STATE OF MICHIGAN
DEPARTMENT OF
ENVIRONMENT, GREAT LAKES, AND ENERGY
LANSING

SUBJECT: Michigan Department of Environment, Great Lakes, and Energy (EGLE) Comments on the Draft Supplemental Remedial Investigation (SRI) Report, Revision 1, dated September 30, 2021, Area 5 of Operable Unit 5 (OU5), Allied Paper Inc./Portage Creek/Kalamazoo River Superfund Site (Site).

GENERAL COMMENTS

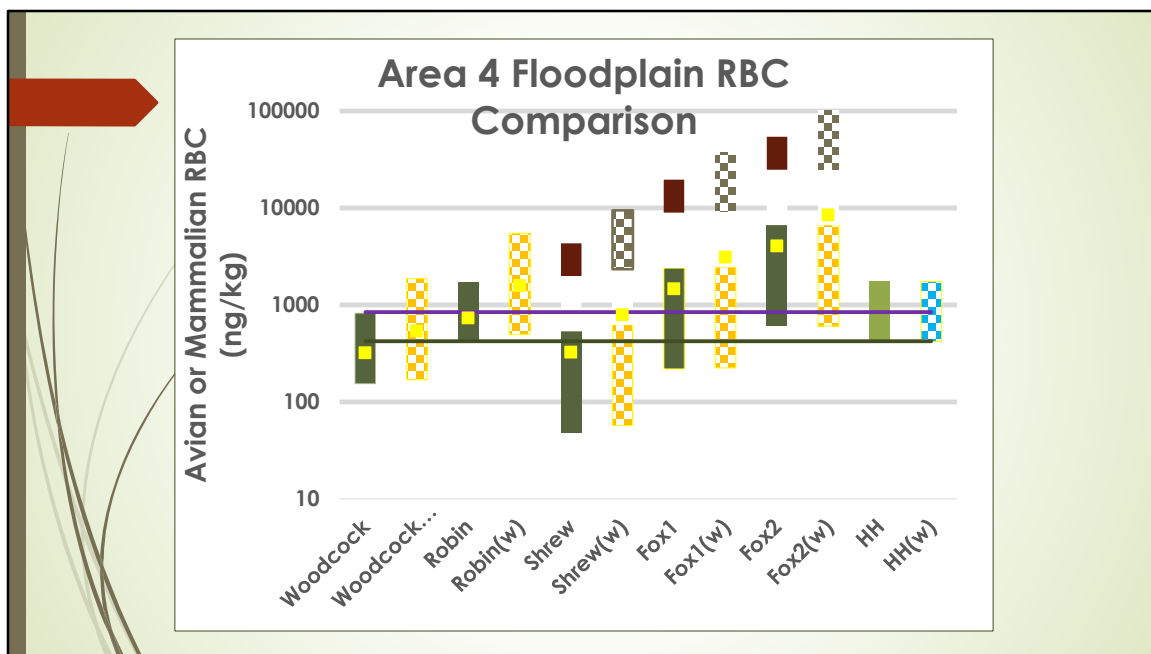
3. Earthworm BAFs are both the foundation of, and the risk drivers for, the derivation of RBCs. The earthworm BAFs used by Wood/GP are orders of magnitude too low because they were derived through a very complex set of mathematical manipulations performed on only two soil samples from the Sonford, MS site (Sonford data was put through normalization/denormalization/renormalization for soil TOC and tissue lipids, along with weighting/deweightings/reweighting TEFs based on the mixtures of D/Fs). The current RBCs (and the potential remediation) are wholly based on two

soil samples from a site in another state. This approach is unacceptable.

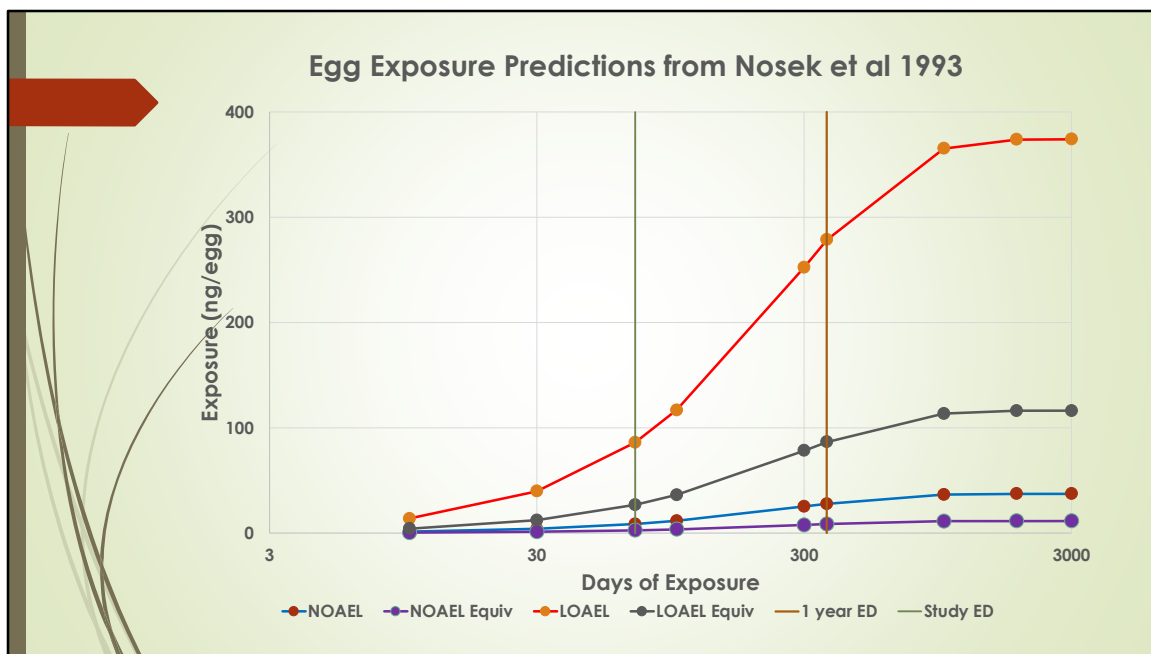
1. This figure uses literature data to demonstrate the steep dose response curve for egg injection studies. The data and calculations are provided in the accompanying Excel file titled: "Embryotoxicity_Cohen-Barnhouse_060418".

2. For PeCDD, control to 100% mortality occurs over a range of 0 to 10 ng/egg.
3. An LD₂₀ (a non-conservative endpoint to use to quantify a lethality LOAEL) would be in the range of 2 ng/egg (control mortality was about 20 percent so that an increase of 20% would occur at about 3 ng/egg).

4. The egg injection study results compare well with results of hen dosing reported by Nosek et al. The ED₅₀ for hen toxicity occurs at a slightly higher dose than does embryo mortality. Further, any LD₅₀ for embryo mortality is consistent with almost complete mortality in egg injection studies. Exposure rate for hens that result in a dose to eggs in the range of a few ng/egg are likely to result in significant impacts.

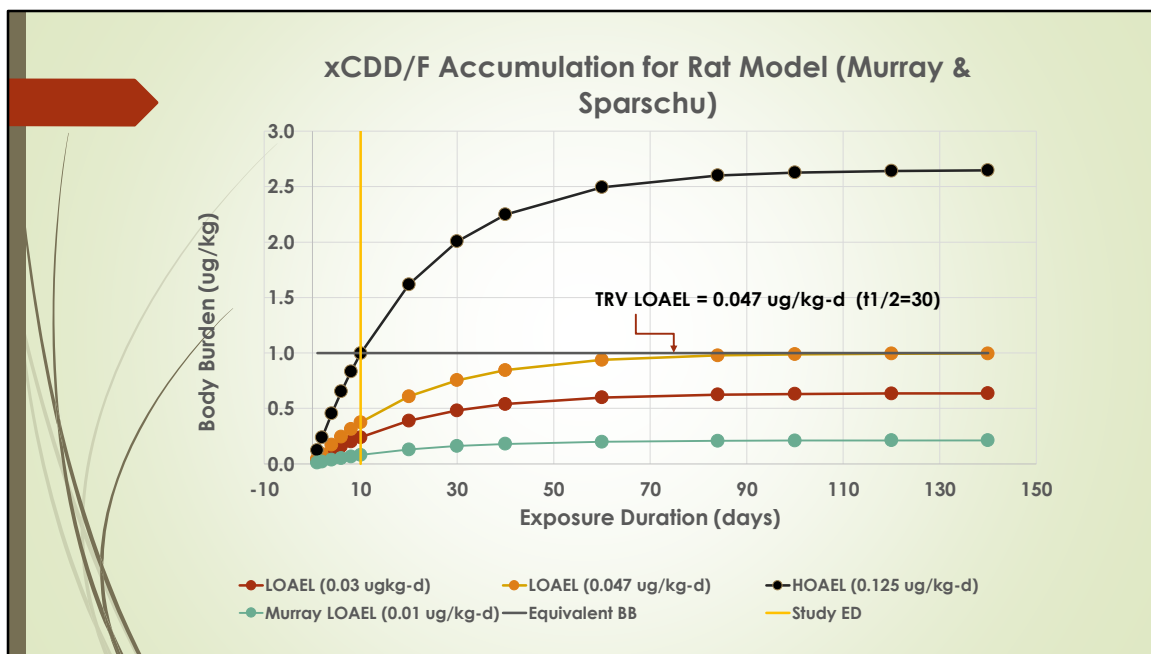
1. This chart plots predicted body burdens for rats at exposure rates used in the Murray et al. and Sparschu et al. studies. Data and calculations for all of the analysis are provided in the accompanying Excel file titled: "xCDD_Accumulation_Rat_Predictions_060418".

2. Body burden is used as a surrogate for plasma concentrations since volume of distribution of xCDD in rats is not known.
3. Calculations assume a half-life for xCDD of 30 days. This assumption is reasonable for lower chlorinated congeners, but likely underestimates half-life for congeners with higher levels of chlorination.

4. Sparschu et al. reported impacts after 10 days of exposure of embryos at a dose rates of 0.125 ug/kg-d and higher. Toxicity was not observed at a dose rate of 0.03 ug/kg-d over the same time period. The short exposure duration does not allow for bioaccumulation and significantly underestimates body burden after longer exposure periods.

5. The Study ED line shows point in time where investigators ceased dosing.
6. Predicted body burden is much higher if exposure is assumed to continue for several half-lives. To recalculate a RBC based on body burden, an exposure rate was estimated that results in a body burden after 100 days of exposure that is similar to the body burden predicted at 10 days. This dose rate (0.047 ng/kg-d) is

recommended as a upper range estimate of LOAEL (i.e., a dose rate that is likely to result in significant toxicity).

7. Similarly, a dose rate of 0.011ug/kg-d for a 100 day exposure duration predicts the same body burden as estimated for a 10 day exposure, which is essentially the same as the LOAEL estimated in the Murray et al. study.
8. Recommendations for mammalian TRVs are therefore: NOAEL = 0.001 ug/kg-d (Murray et al.); LOAEL = 0.01 ug/kg-d (Murray et al. and Sparschu et al.); LOAEL (upper range estimate) = 0.047 ug/kg-d (Sparschu et al.).
